# Replacing the Morr/Pulsafeeder 3 wire electrode with the Advantage part TE-3A

The Advantage Controls conductivity electrode part number TE-3A is a direct replacement for the Morr/Pulsafeeder part TE-2A.

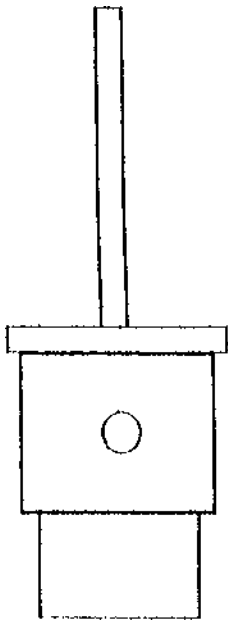
The mounting tees for the two electrodes are different, so a change must be made to the piping. Electrically both parts are identical. All that is required is that the wiring color code be matched up as per the diagram below.

## Wiring of Electrodes

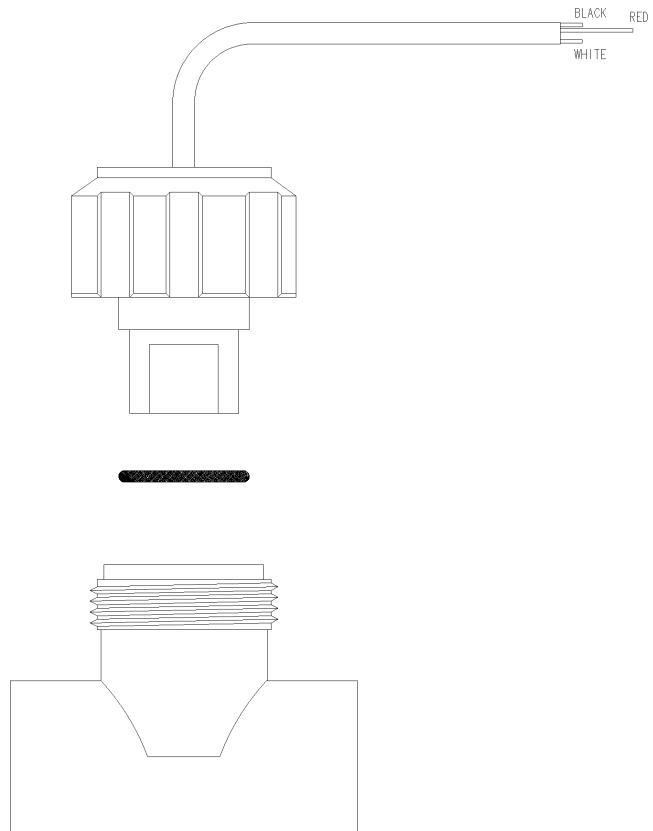
Pulsafeeder Controller		Advantage TE-3A Electrode
Red	Electrode	Green or white
Black	Electrode	Black
Green	Temp.Comp.	Red
